Louisiana Energy Services  
Response to April 29, 2004,  
Request for Additional Information

Louisiana Energy Services (LES)  
Responses to April 29, 2004  
Requests for Additional Information

Figure ER RAI 2-1  
DATE: 5/20/04

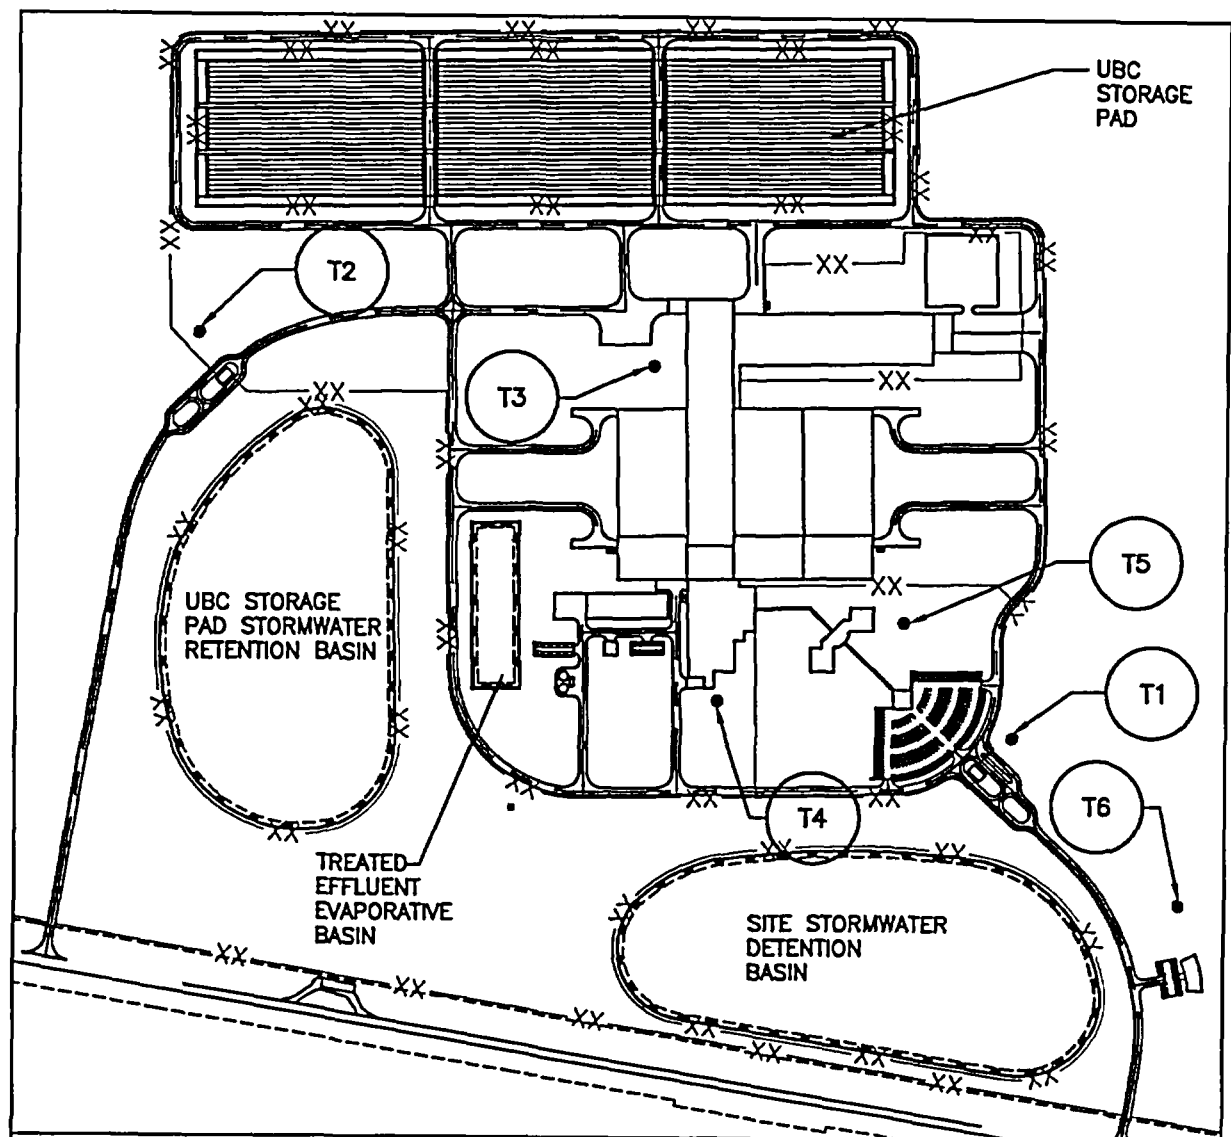
Provide a map or a figure to show the current CO<sub>2</sub> line location through the proposed NEF.

- Sections 2.1.2.1, 2.1.2.5, 4.1.1, and 4.1.2. state that the Trinity Pipeline, LLC, 10-in diameter, 2000 psi, underground CO<sub>2</sub> pipeline traverses southwest to northwest across the proposed NEF and would be re-routed but no maps show the current location of the pipeline.

Figure ER RA12-7C.1

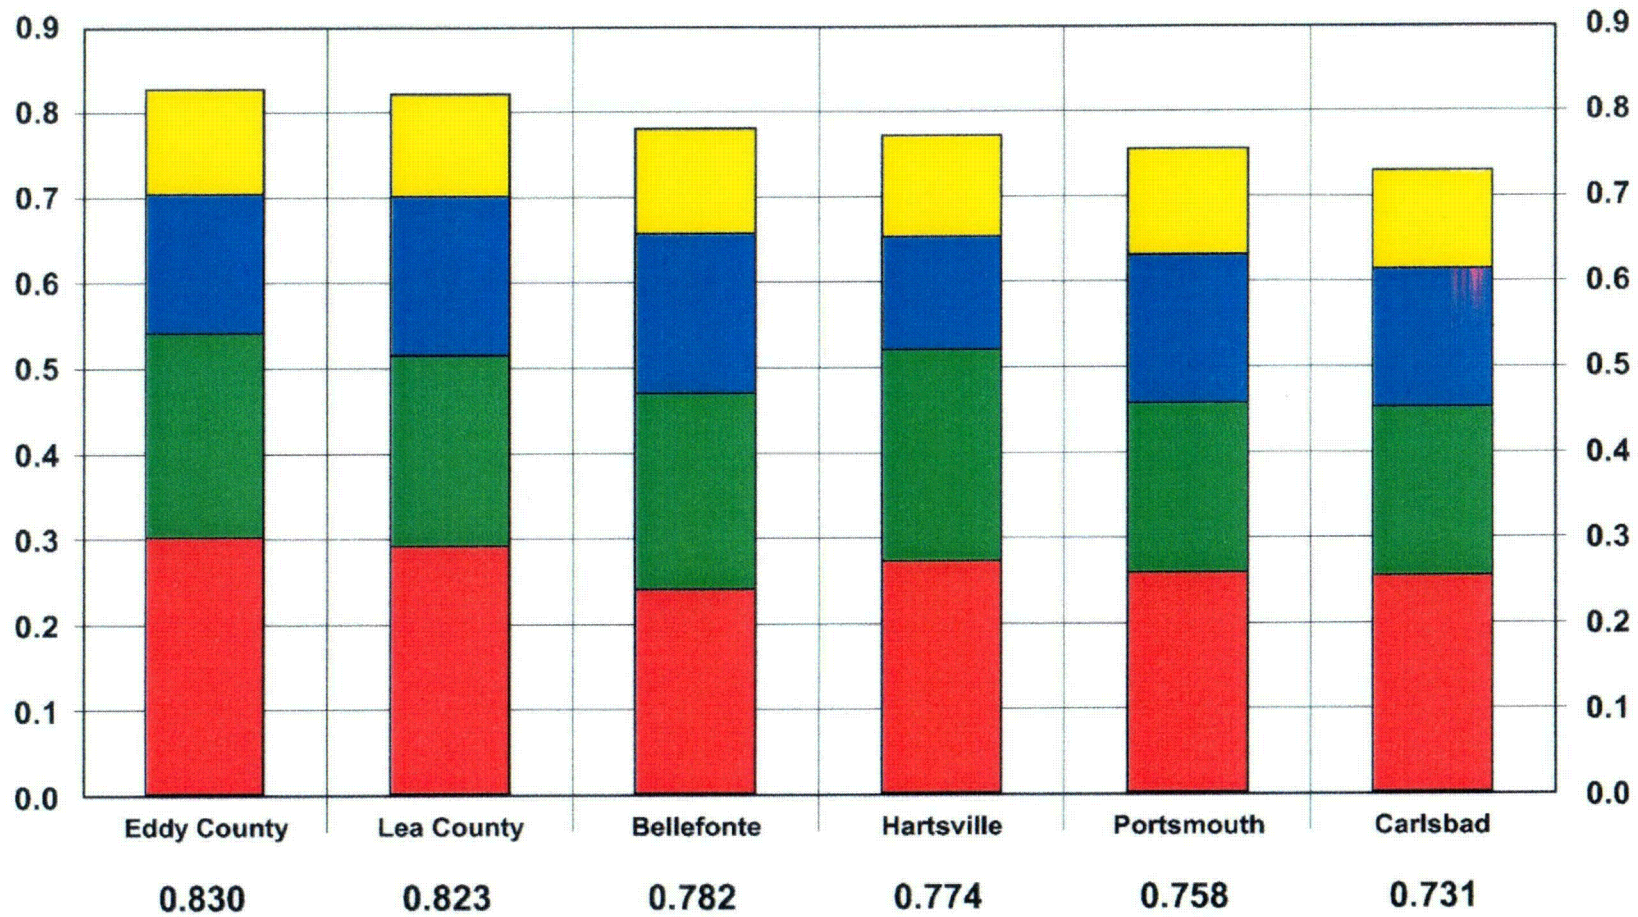
- C. Verify that the description of the Eddy County site is accurate in Section 2.1.3.3.4.2.
- The written description of the location of the Waste Isolation Pilot Plant (WIPP) access road and utilities indicate that the correct site is Section 11 of Township 22S, Range 31E of the New Mexico Meridian which is northeast of the current WIPP site. Section 2.1.3.3.4.2 identifies the Eddy County site as Section 8 of Township 22S, Range 31E of the New Mexico Meridian which is near the northwest corner of the WIPP site.

- C. The description of the Eddy County site in ER Section 2.1.3.3.4.2 is correct. Figure ER RAI 2-7C.1, "Aerial View of Eddy County Site," in Attachment 3 to this submittal provides an aerial view of the Eddy County site. As described in Section 2.1.3.3.4.2 and as shown on Figure ER RAI 2-7C.1, the main WIPP access road is on the southeastern edge of the site.

FIGURE ER RAI 3-3

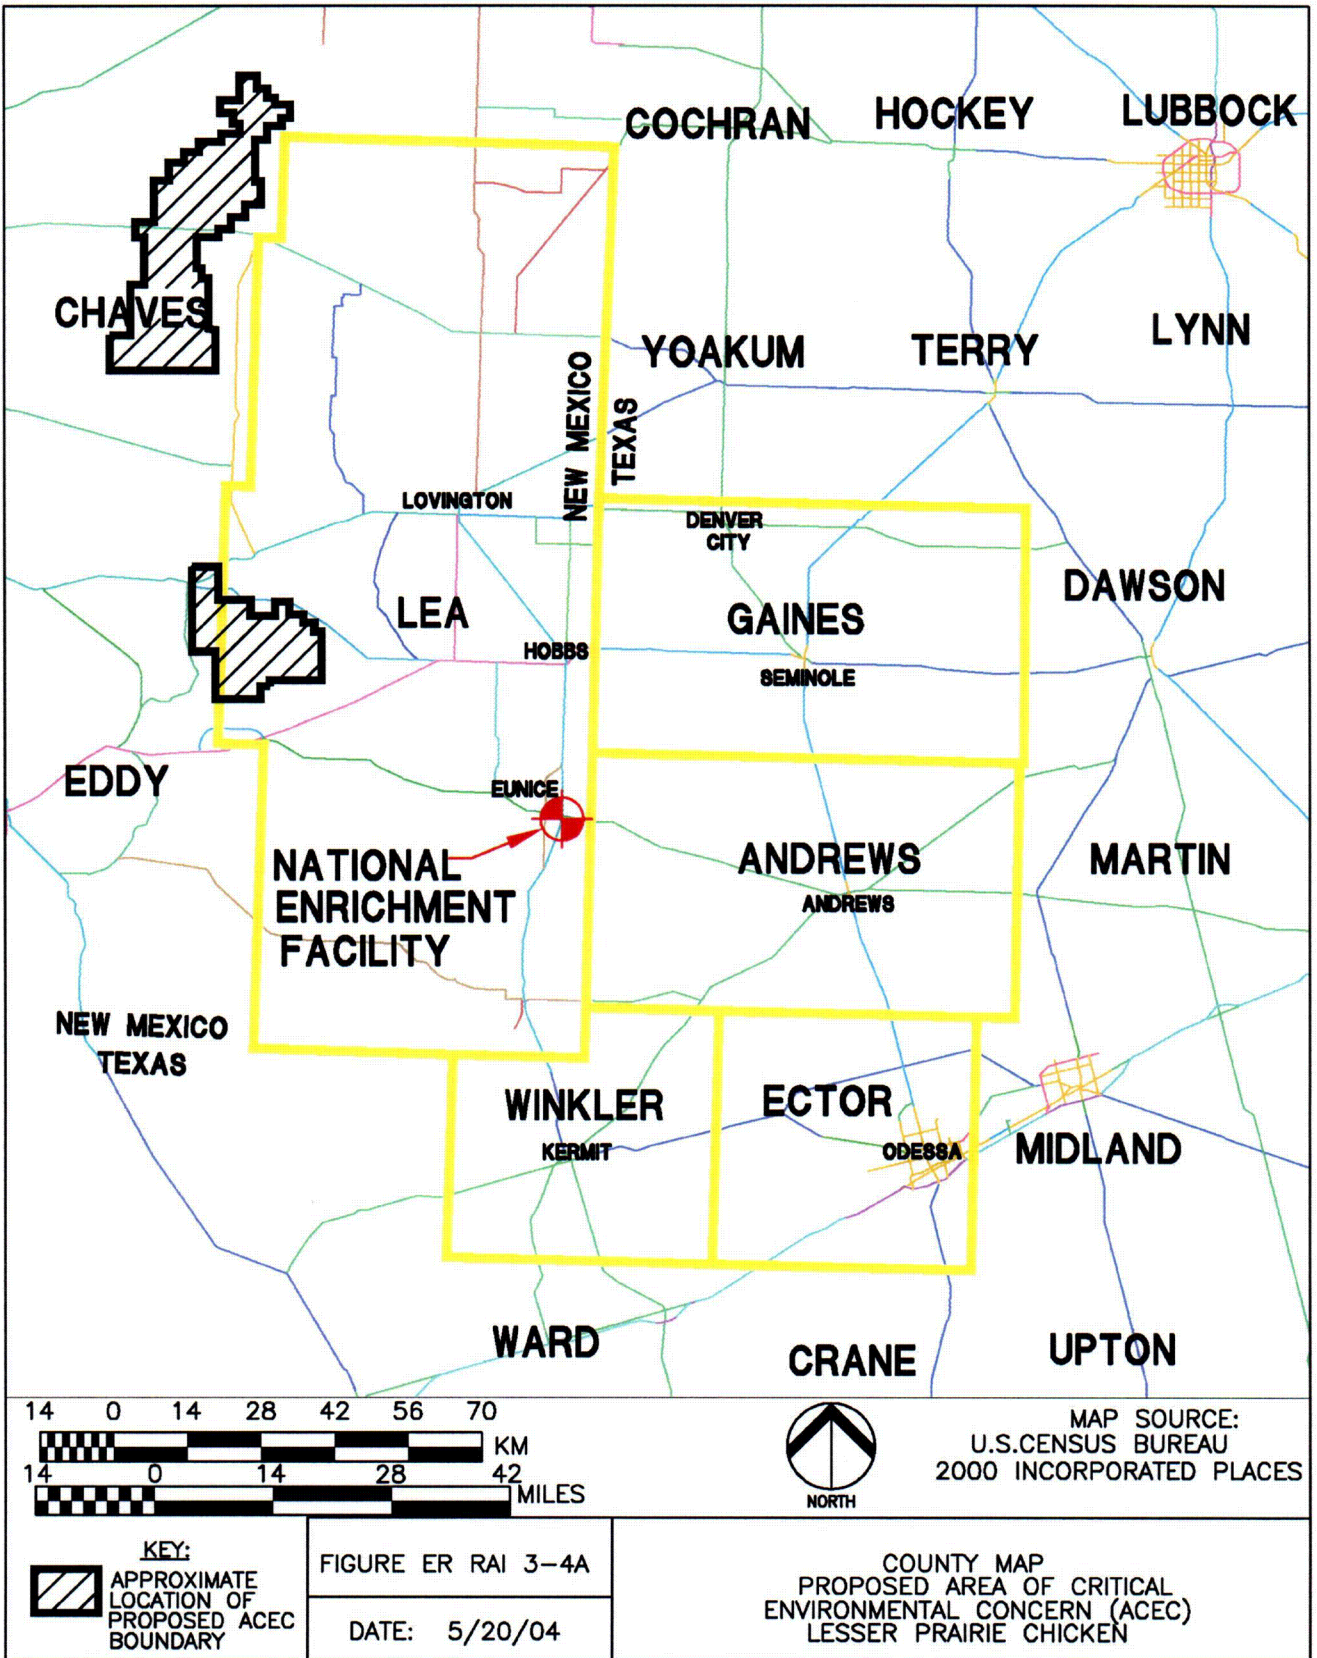
Provide the correlation analyses of the meteorological data from the Midland-Odessa, Texas Airport with the Waste Control Specialists (WCS) meteorological data.

As shown in Table ER RAI 3-3.1, the prevailing wind direction has a southerly component at both sites. Figure ER RAI 3-3, "Comparison of Wind Direction Data," provided in Attachment 3 to this submittal, provides a graphical comparison of the WCS and the Midland-Odessa wind direction frequency distribution. A comparison of the WCS and Midland-Odessa data provided in Table ER RAI 3-3.1 and in Figure ER RAI 3-3 shows good agreement in wind direction frequency between the two sites even though the meteorological data are from different time periods and the two sites are separated in distance and are at different elevations.
